**RE: Summary of Technical Work  
Proposed Redevelopment at 1234 – 1246 Richmond Street, City of London**

**SUBJECT: File No: OZ-8552 – UTRCA Comments on Flood Path Assessment**  
**Applicant: Textbook (Ross Park) Inc., 1234-1246 Richmond St., London**  
**MMM Project: 1016024-001-SW1**

**Re: File No. SP12-012179 - Application for Site Plan Control**  
**Applicant: 2180040 Ontario Limited**  
**Agent: Zelinka Priamo Ltd.**  
**1235-1253 Richmond Street, London, Ontario**

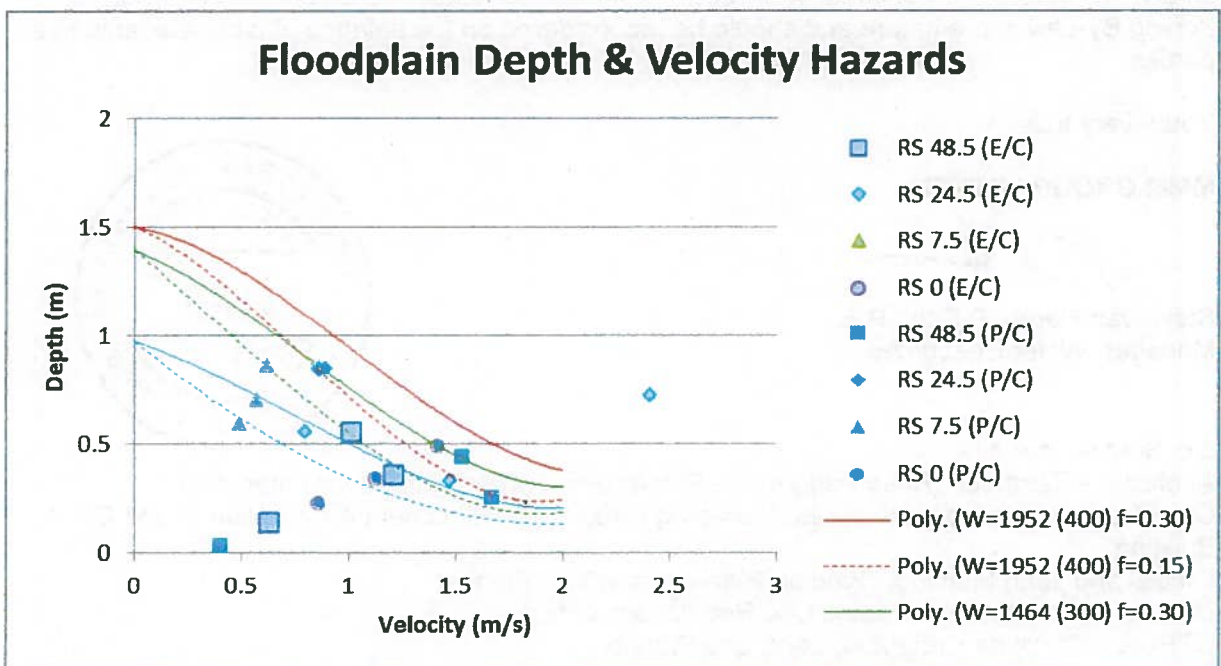
Secondly, to address your points on pedestrian access on the site and the significantly more stringent requirements, I have plotted the Flooding Depth & Velocity products from Tables 1 & 2 from our flood path analysis against the recommended curves from Appendix 6 of the MNR Technical Guide. The Existing Condition (E/C) values clearly show the outlier value that is outside of safe limits for pedestrians. The Proposed Condition (P/C) values are all within the various ranges for different sized individuals. As we have stated in our Flood Path Assessment, we acknowledge that the site is subject to flood risk, but the analysis below demonstrates that the post-construction risk is tolerable. Additional means to further improve stability under flood conditions can be investigated at the detailed design stage (such as material treatments to increase friction on surfaces during flood conditions and/or lighted pathways with lower overall flood depths and velocities with possible surface treatments to convey pedestrians from building exits to marshalling areas.)

You make reference to the draft Broughdale Dyke Flood Characterization study (DRAFT – May 2016), and state that it has technical information that can inform questions “regarding floodway/flood-fringe/access in the Broughdale area”, and state that your preliminary review confirms that safe access does not appear feasible, and that the subject lands should be considered to be located within the floodway (not within the flood fringe). We note this draft report has not been circulated to our team, and therefore we cannot provide any challenge to the findings therein or concur with them, yet the findings of the draft report based on your review to date are cited as the reasons to declare that safe access is not feasible.
